ALERT SERVICE BULLETIN

NO. 222U-99-56
DATE 12/16/99
PAGE 1 of 4

MODEL AFFECTED: 222U

SUBJECT: TAIL ROTOR PITCH CHANGE BEARINGS P/N 222-312-753-103, INSPECTION OF; AND TAIL ROTOR BLADE ATTACHING HARDWARE, REPLACEMENT OF

FIGURE 1

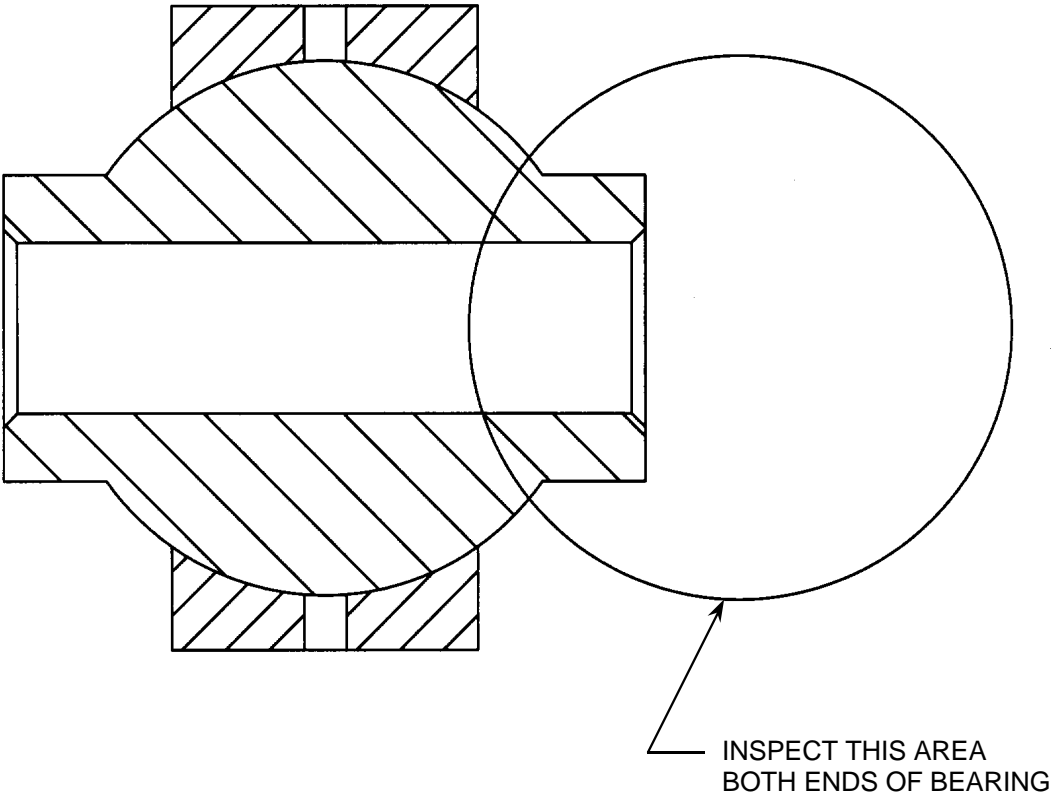
3. Visually inspect each bearing inner member neck area (full 360 degrees) for cracks. Refer to figure 1. If crack(s) are found in a bearing, the replacement of both bearings in that blade are required. Refer to BHT-222-CR&O-3.
